Murphy Bed Mechanism

Bulletin Type:	Recall	Publication Date:	November 2025
Bulletin #(s):	25V-675 USA 2025-542 Canada	Make(s):	Jayco, Heartland
Job Code(s):	9901639	Model(s):	North Point FW, Bighorn
Flat Rate(s):	9901639 1.5 HR – Murphy Bed Mechanism Replacement	Model Year(s):	2026

MURPHY BED MECHANISM REPLACEMENT INSTRUCTION

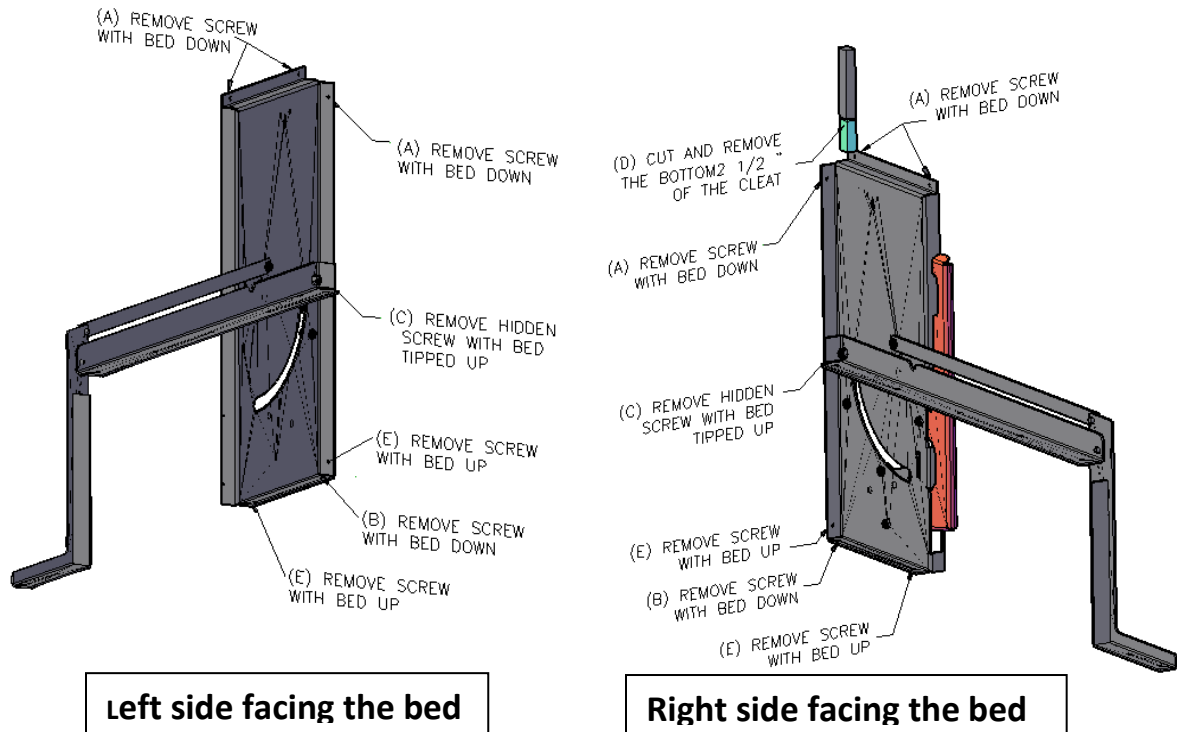
1. This process will require two technicians to complete. This process should be followed to prevent the mechanism from springing free unexpectedly from the wall.
2. A support frame below that is 42" x 6 1/2" is to be built according to the provided drawing. This will be used later in the process once the screws attaching the mechanism to the wall have been removed. The bottom side of the 2 x 4 x 6 1/2" needs to be duct taped to protect the floor.

4. One technician will be required to lay on the floor under the bed to remove several screws while the other technician lowers the bed to rest on the floor and removes the 3-screw marked **(A)** in both the Left and Right mechanism.

5. The technician under the bed will need to **remove only the screw identified in the diagram above that are marked as (B)** otherwise the bed may spring away from the wall. This 1-screw is found in both the Left and Right mechanisms.

7. The wood cleat located above the Right mechanism must be shortened by 2 ½" as the new mechanism is taller and this clearance is needed as indicated by **(D)** in the diagram above.

9. The final two screws indicated in the drawing are now to be removed and marked as **(E)**. A 12" long screw bit will be required. The bed assembly is now free to be moved to replace the mechanisms.
